No. EC120-24-015

SERVICE BULLETIN

ELECTRICAL POWER - Electrical master box

Separation of the direct battery distribution from the electrical master box

Figure 1

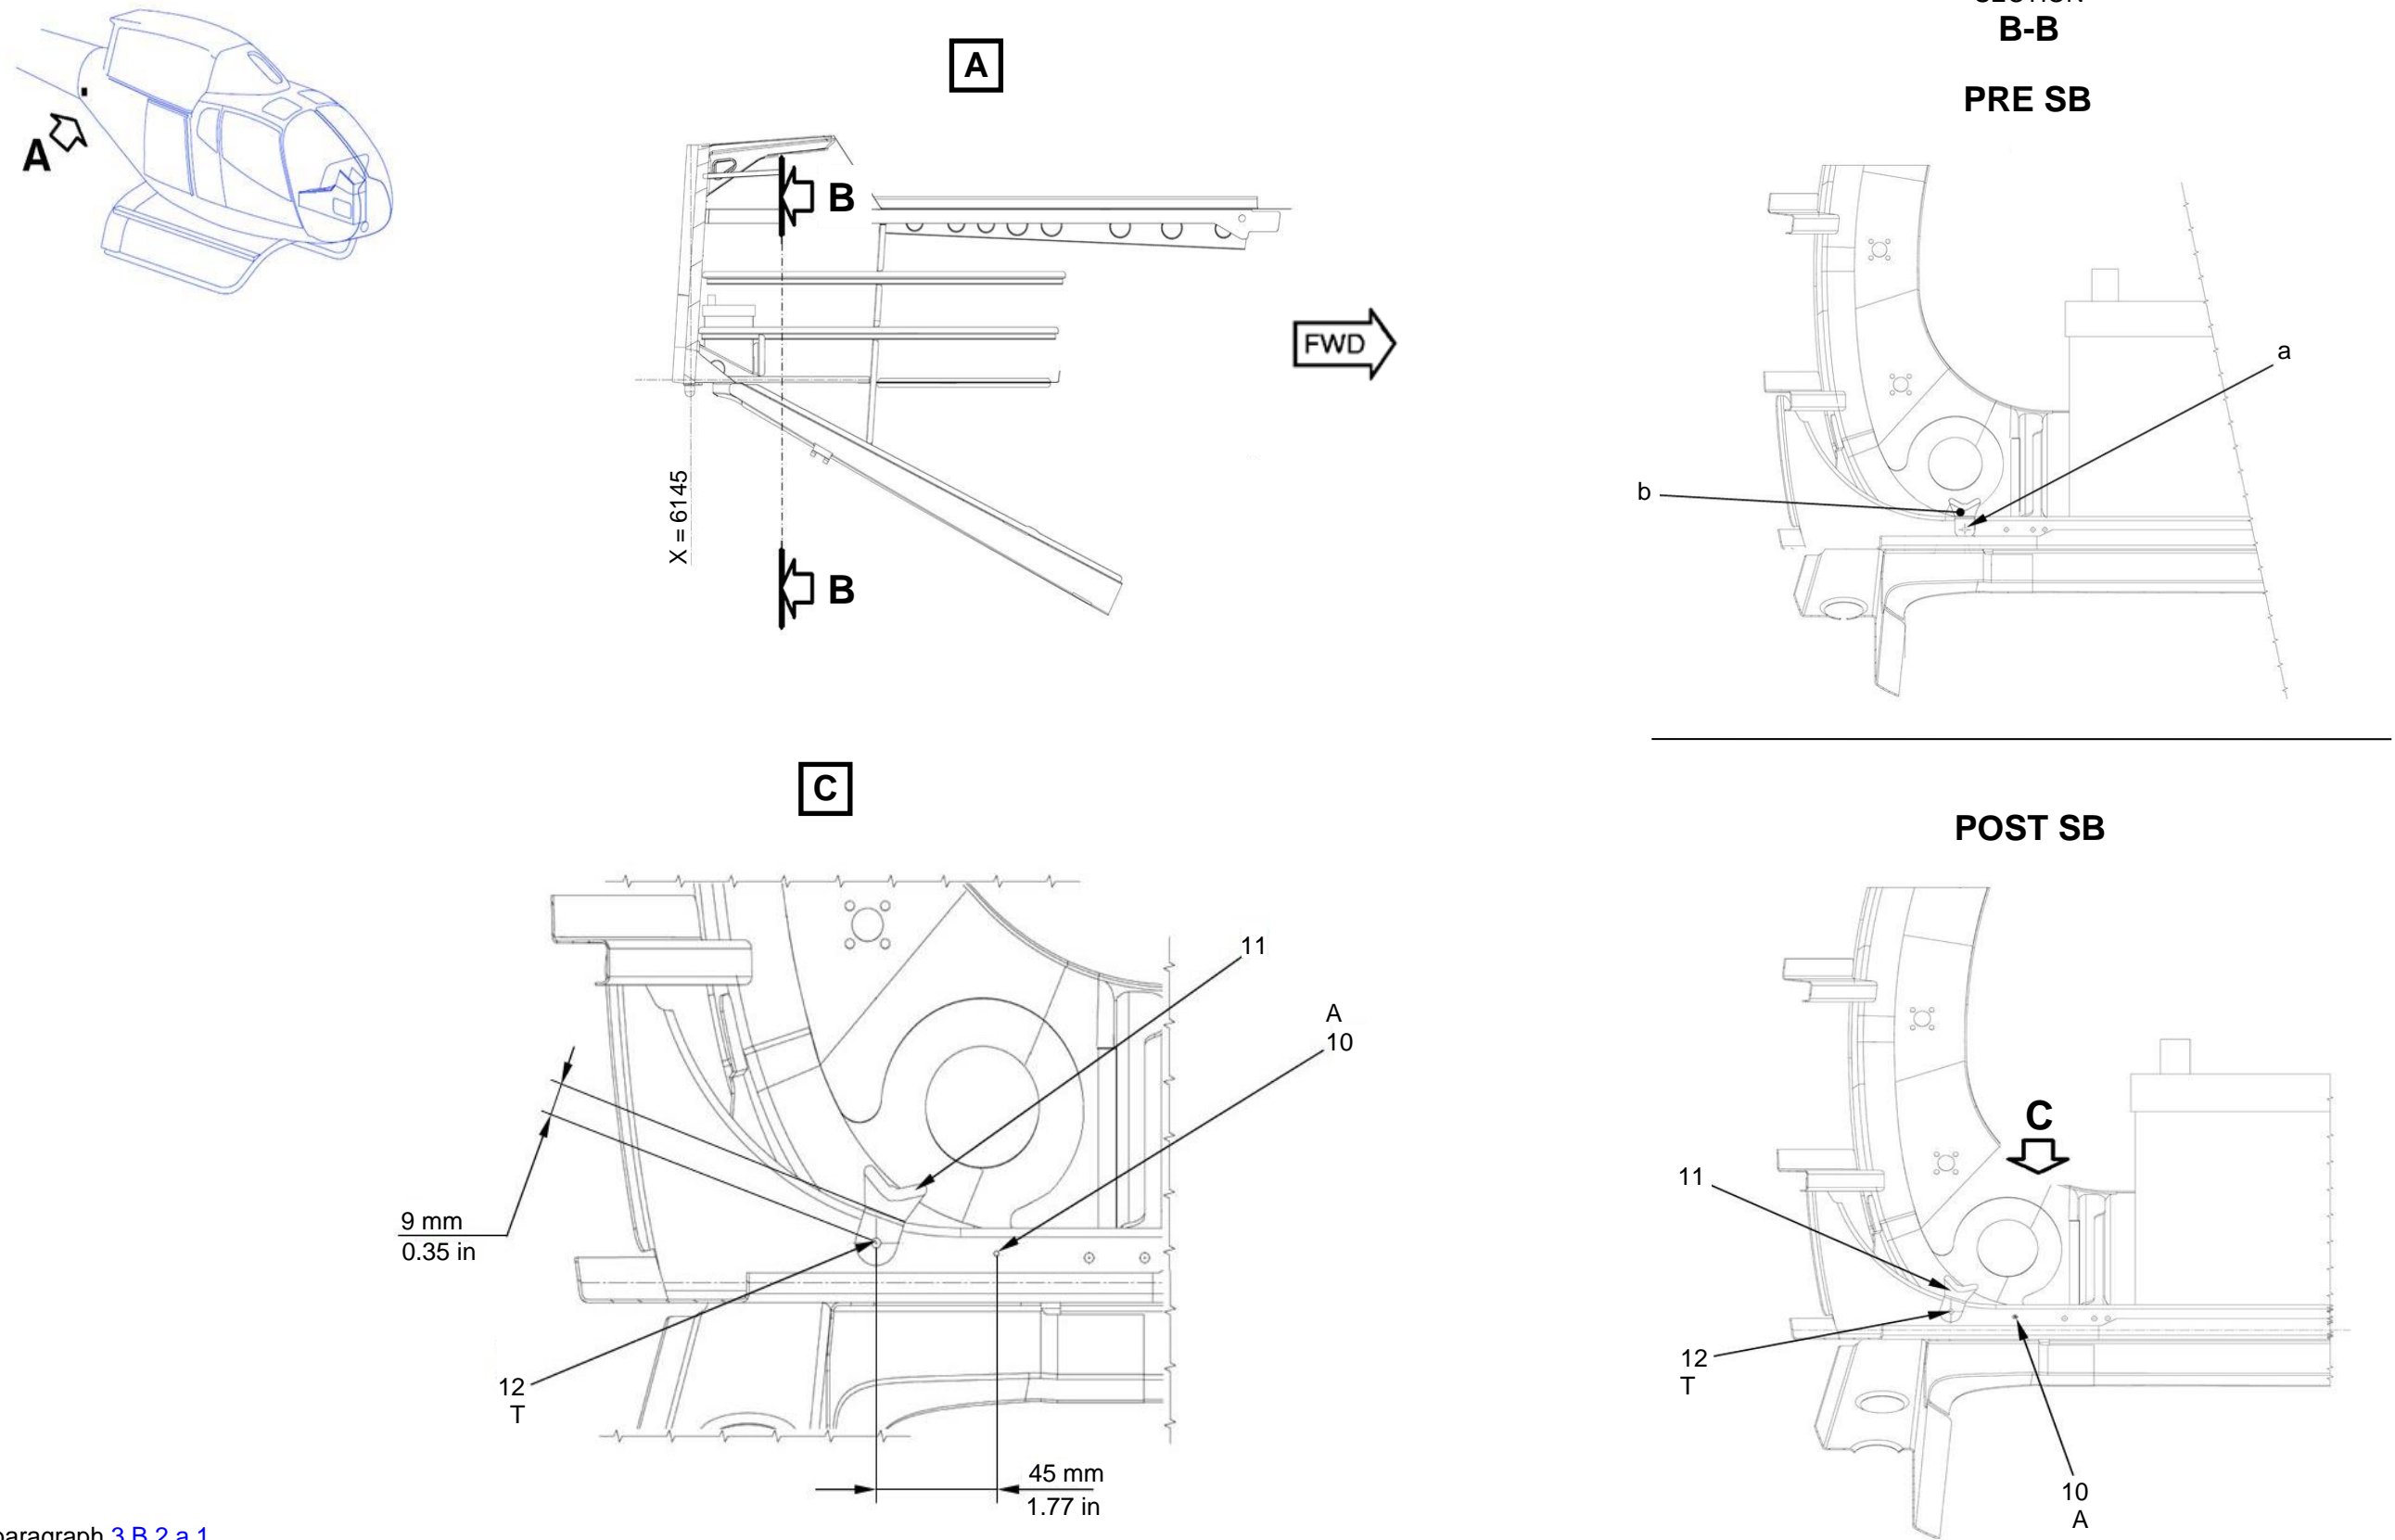
- Remove and discard the rivet (a).
- Remove and discard the clamp support (b).
- Drill rivet hole (T) using a 3.3 mm (0.129 in) diameter drill.
- Deburr and clean the area.
- Perform touch up on the rivet holes (A) and (T) with chemical conversion material (30) as per Work Card 20-04-04-403 (MTC) (not shown in figure).
- Install rivet (10) in the rivet hole (A) (SECTION B-B, POST SB).
- Install the clamp support (11) using rivet (12).
- Perform touch up on the rivets (10) and (12) with P05 epoxy primer (28) as per Work Card 20-04-05-402 (MTC) (not shown in figure).

- Remove the rivets (10) and (12).
- Deburr and clean the rivet holes (A) and (T).
- Perform touch up on the rivet holes (A) and (T) with the chemical conversion material (30) as per Work Card 20-04-04-403 (MTC) (not shown in figure).
- Install new rivet (10).
- Install the clamp support (11) with new rivet (12).
- Perform touch up on the rivets (10) and (12) with the P05 epoxy primer (28) as per Work Card 20-04-05-402 (MTC) (not shown in figure).

Figure 2

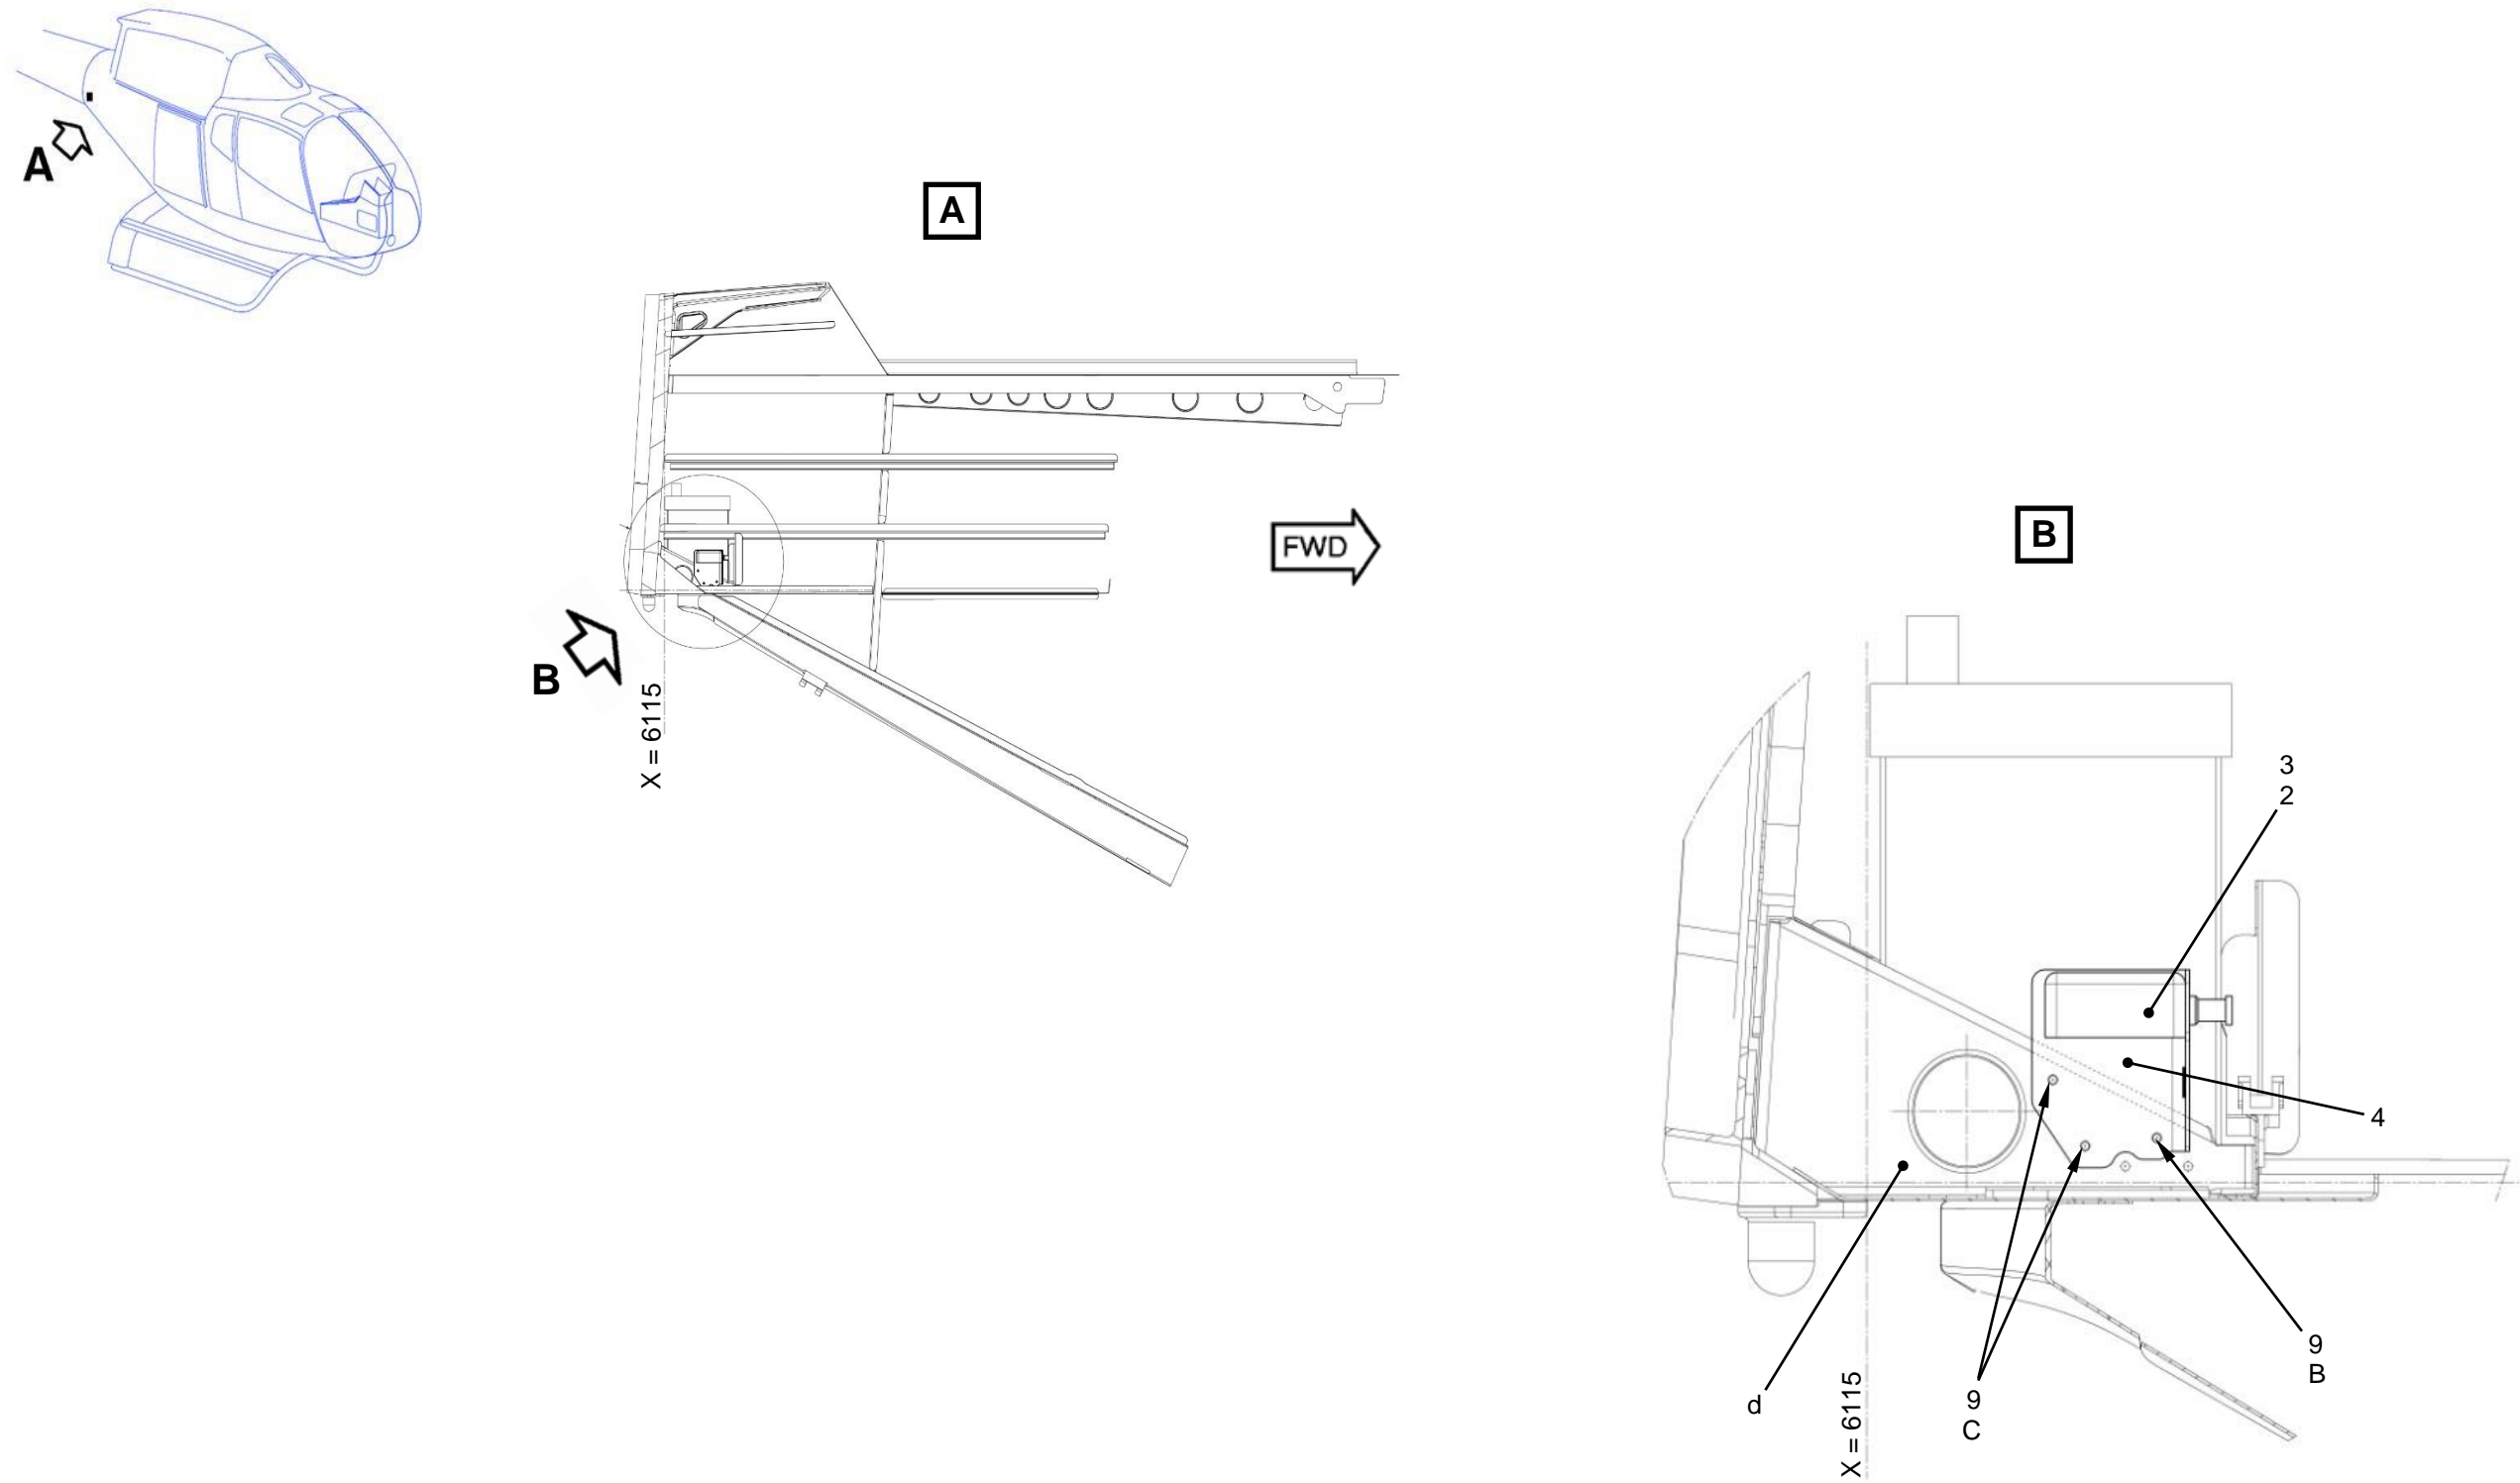
- Remove circuit breaker (2) and circuit breaker cover (3) from circuit breaker support (4).
- Keep the circuit breaker (2).
- Unrivet the circuit breaker support (4) from RH web (d).
- Discard the circuit breaker cover (3) and the circuit breaker support (4).
- Perform touch up on rivet hole (B) with the chemical conversion material (30) as per Work Card 20-04-04-403 (MTC) (not shown in figure).
- Install rivet (9) into the rivet hole (B).
- Perform touch up on the rivet (9) with the P05 epoxy primer (28) as per Work Card 20-04-05-402 (MTC) (not shown in figure).
- Enlarge fixation holes (C) on the RH web (d) using a 4.2 mm (0.165 in) diameter drill.
